Office Action Summary

10/510,290

WEHLER ET AL.

DETAILED ACTION

F i g. 6

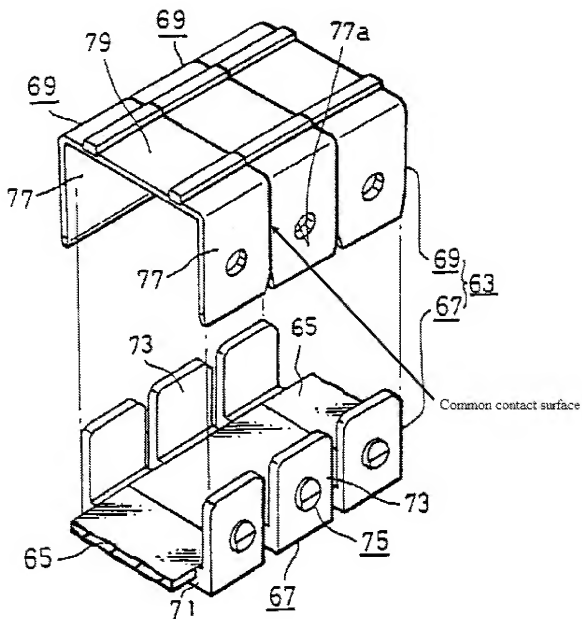
Claim 25 is rejected under 35 U.S.C. 102(b) as being anticipated by Fukao (US Patent 5,836,148). Fukao discloses a line guidance unit for guiding lines, the line guidance unit having a loaded condition and an unloaded condition, and comprising: a first fixed end; a second movable end; a plurality of segments (63) disposed between the first fixed end and the second movable end and each segment includes an overlap region (Figure 6, 77 and 73) and the segments define a line channel; a longitudinal support strip (65) joining at least three segments and extending between the first fixed end and the second movable end; and a common contact surface on each segment overlap regions and each common contact surface engages the common contact surface on an adjacent segment to dispose the line guidance unit in an arc-shape when the line guidance unit is in unloaded extended condition and for resisting loads when the line guidance unit is in the loaded condition (See attached Figure 6 on page 5 of this Office Action).

FIG. 2

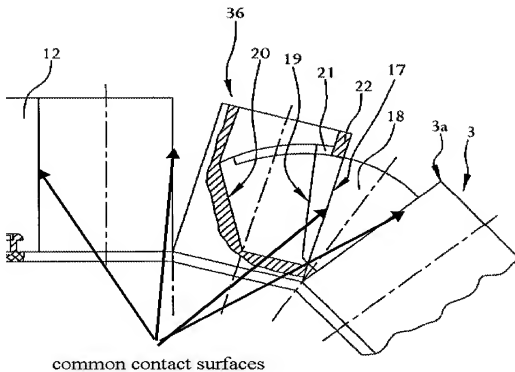
With regards to claim 5, Blasé discloses wherein the common contact surface is a bearing surface between a protrusion (18) formed on a segment and an adjacent segment when the line

In addition, to further clarify the “common contact surfaces” in the Blasé reference, please see attached Figure 2 below.
